Ott Water Engineers  
150259 Jim Ford Creek Hydro  
General

KIM DE RUBERTIS  
CONSULTING ENGINEER

SUBJECT: Jim Ford Creek Hydroelectric Project

RE: JIM FORD CREEK HYDROELECTRIC PROJECT  
GEOTECHNICAL EVALUATION AND RECOMMENDATIONS  
WEIPPE, IDAHO

*Cross Section Through Slide of March, 1989*

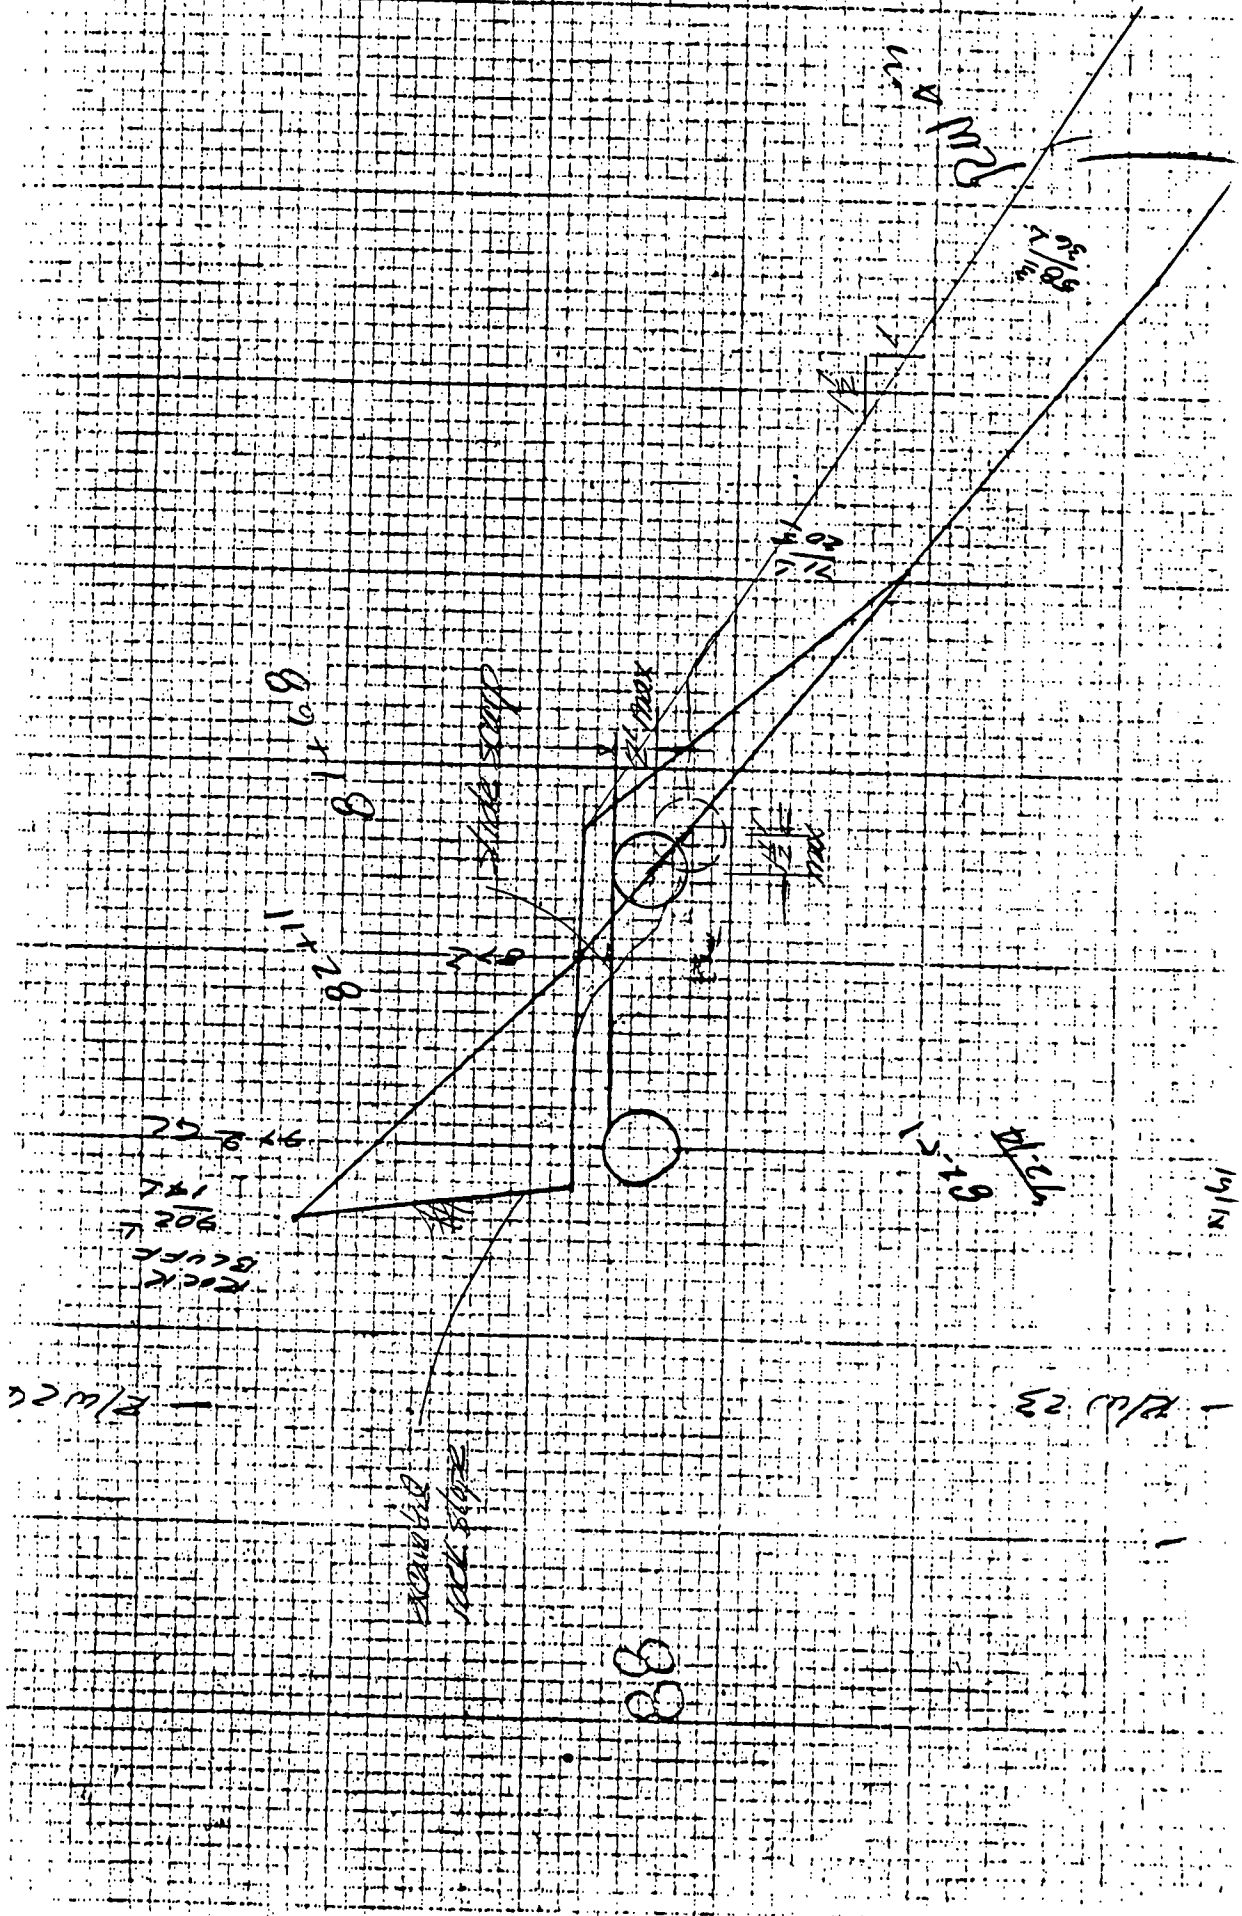
**Observations.** Figures 1 and 2 show the approximate location and condition of the slide. [Several photographs will be added showing the conditions observed.] The slide occurred roughly between stations 81 + 25 and 82 + 75 where the penstock is buried beneath the road and at the transition from 48-in dia CMP to 42-in dia steel pipe. The slide exposed about 60 ft of pipe. The CMP broke a few feet upstream from the transition. I could not see all of the CMP because it was partly buried in earth, but it appeared to me that the pipe split circumferentially in a groove between two corrugations. You had cut a hole into the CMP and reported that inspection revealed the CMP to be bowed for a length of about 15 ft upstream from the break. You said that the steel pipe was too slick to inspect. I did not observe any distortion in the exposed steel pipe.

Movement of the slide appears to parallel the slope below the road, with maximum horizontal and vertical movements of about 1.6 ft and 2 ft, respectively. The length of the slide is about 100 ft. A crack in the earth uphill and parallel to the pipe marks the limit of movement near the center of the road.

The steel pipe does not appear to have moved the same amount as the earth around it. Some road fill was perched on top of the pipe, so it appears that the earth slumped, exposing the pipe and exerting enough force to break the CMP.

**Remedy.** Realign the penstock to take advantage of being able to support it with rock. Anchor the penstock to rock. Improve drainage. Buttress the toe of the slope, especially the slump below station 79+00, with free-draining material.

FIGURE 3.

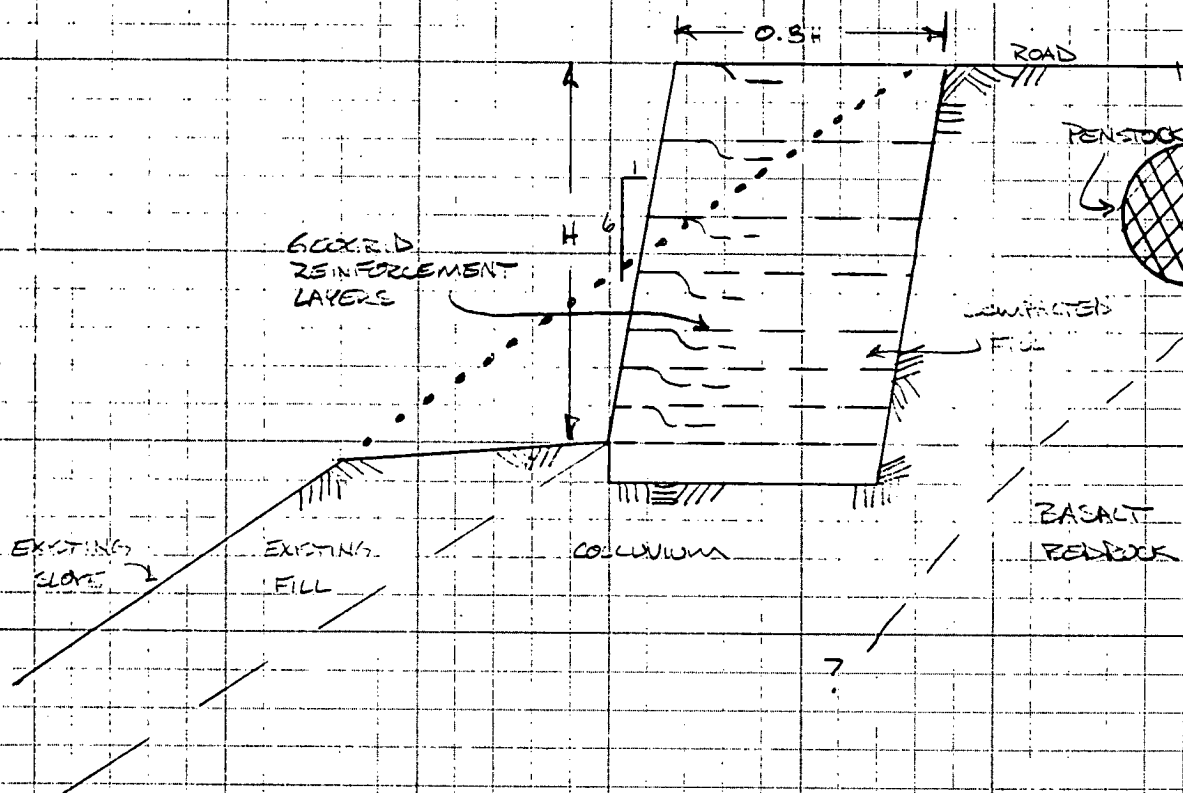
*Cliff,*

There are two problems here:

① On page 5 you call for fill to be compacted to 90% D-1557 with a large steel wheel vibratory roller. But you only have 7' of width, which is insufficient for such equipment. Better use hand compactors or something to be pulled by a JD350.

② How will you get the backslope of the excavation to 60:40 stand at 14:60 while you bring up the reinforced fill? Better think about this some more.
